APPROVE Proposed R-CG Changes*

AMEND Citywide Zoning R-CG
CONTINUE TO SUPPORT MISSING MIDDLE DENSITY

AMENDMENT COMMENTS

OK ↔ GOOD

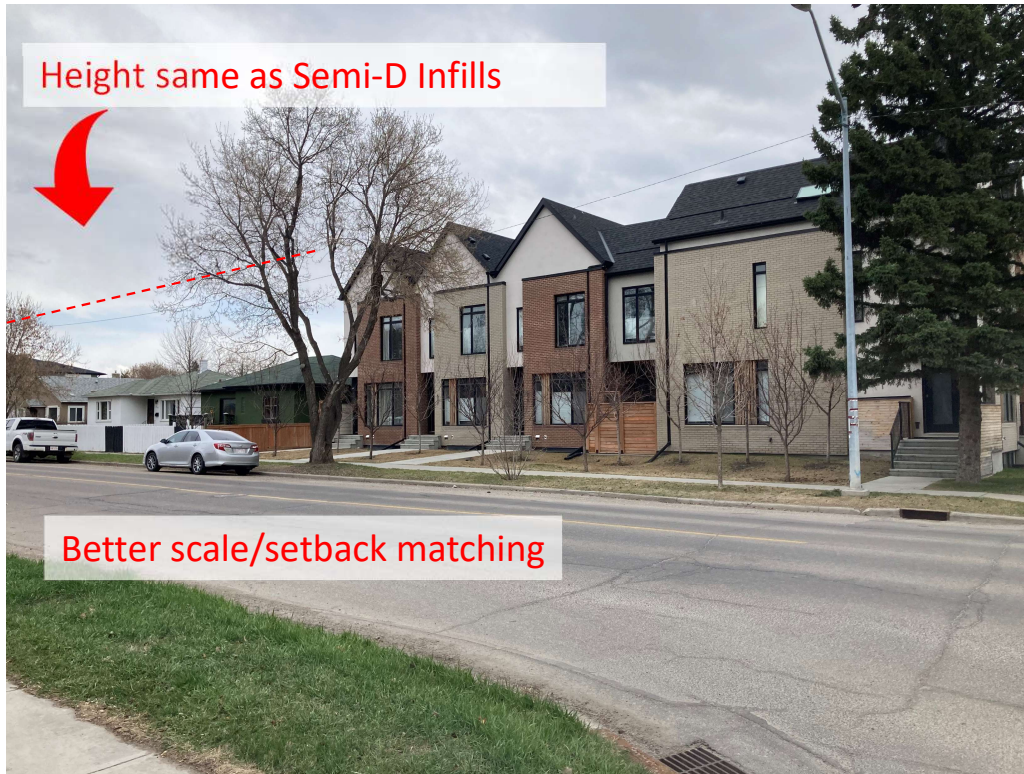
Big wall of Stucco. (1) rotated doorway. Is this REALLY the best you could come up with?

- Reasonable Scale
 - ~matches prior 90-00s infills
 - taller than post-war bungalows
- Architecture & build quality = meh
 - conventional. code built.
- Individual rezoning removed contextual requirements.
Ex. of LAP/hearing failure.
- ZERO INCENTIVE to do anything more than bare minimum

BEST

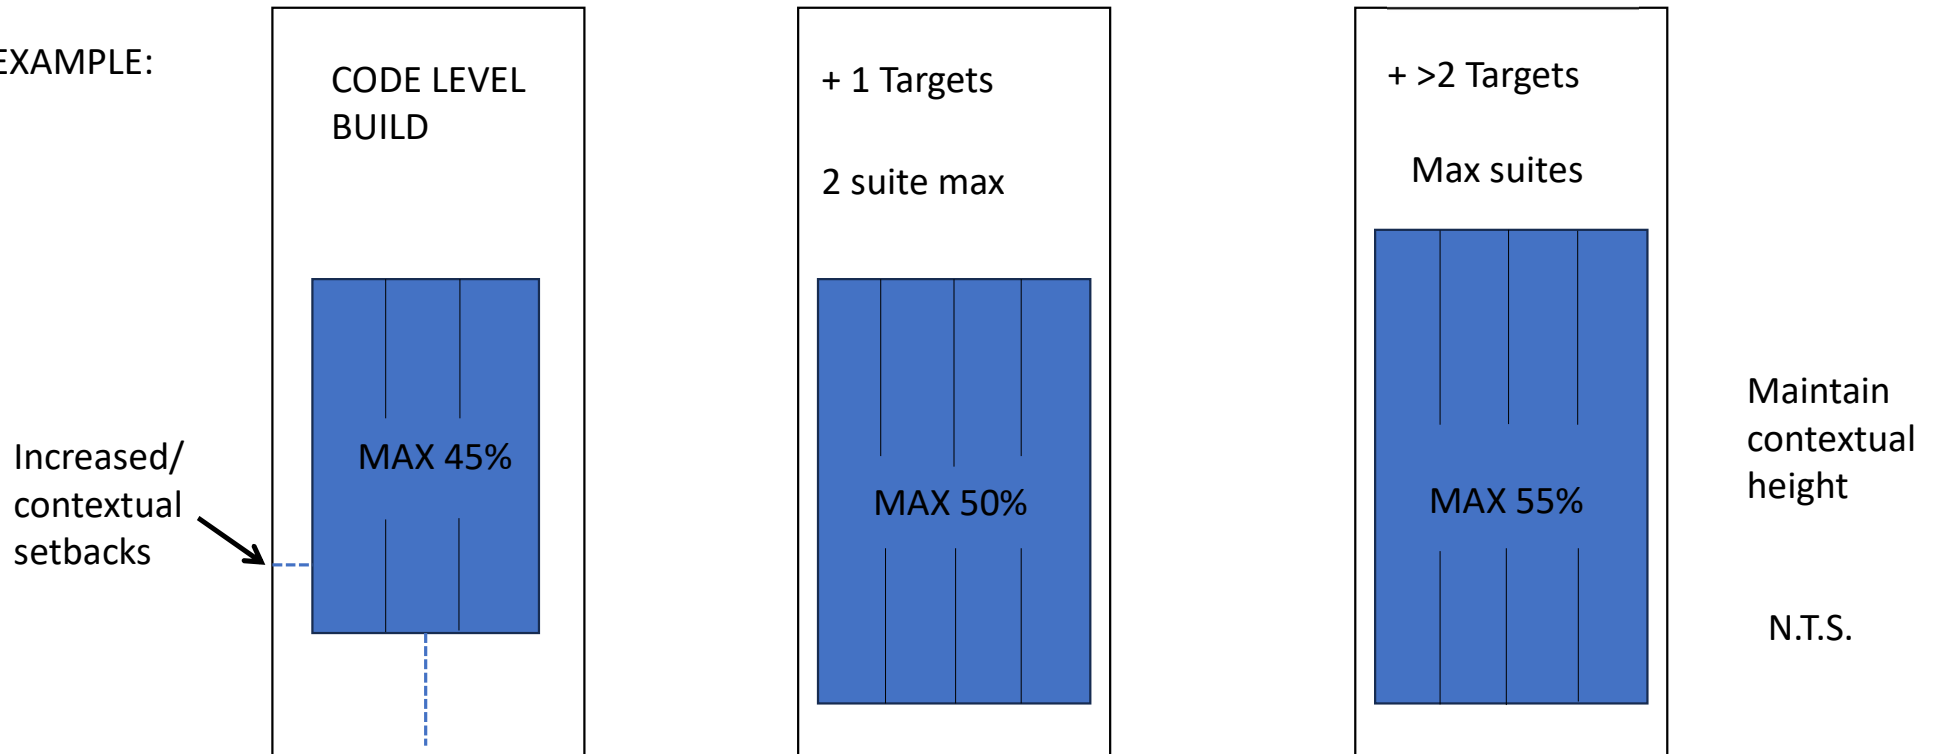
- Reasonable Scale
 - Good fit into the existing dwellings
 - Still taller than post-war bungalow
- Architecture & build quality
 - Local Builder. Familiar with & based in Community.
 - High Energy Efficiency Standard
 - *measured and verifiable targets
 - Market + below Mkt Rents
- What incentive is there to do this?
